Program Bulletin

CUSTOMER SATISFACTION PROGRAM

SUBJECT: Front Knuckle to Hub Attachment Torque

MODELS: 2014-2016 Chevrolet Cruze

2027764

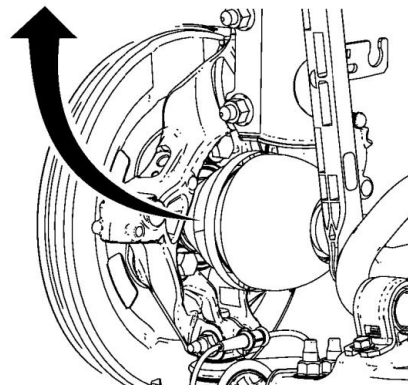
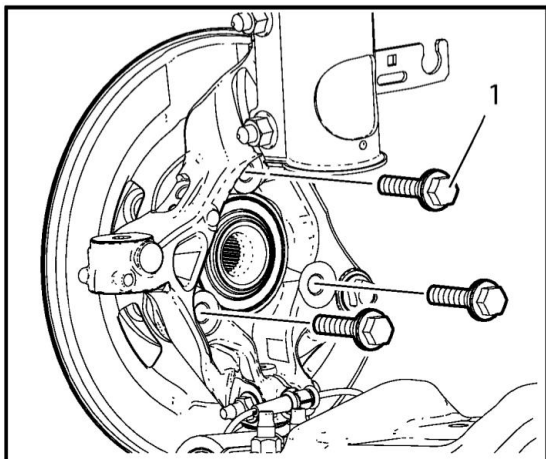
2. Locate the front driver/passenger side bearing/hub bolts.

3. Observe that the fasteners are all present and that no damage has occurred to the bearing/hub. If any damage has occurred replace the bearing/hub and fasteners. Refer to *Front Wheel Bearing and Hub Replacement*.
4. Tighten the bearing/hub bolts (1) in 2 passes. Use the *EN-45059* angle meter. Refer to *Front Wheel Bearing and Hub Replacement* in SI. Ensure to tighten all front driver side wheel bearing/hub bolts.
 - a. First pass to **100 Nm (74 lb ft)**
 - b. Second pass to **20 – 35 degrees**
5. Repeat steps 2 through 4 for the passenger side bearing/hub bolts.
6. Lower the vehicle. Refer to *Lifting and Jacking the Vehicle* in SI.
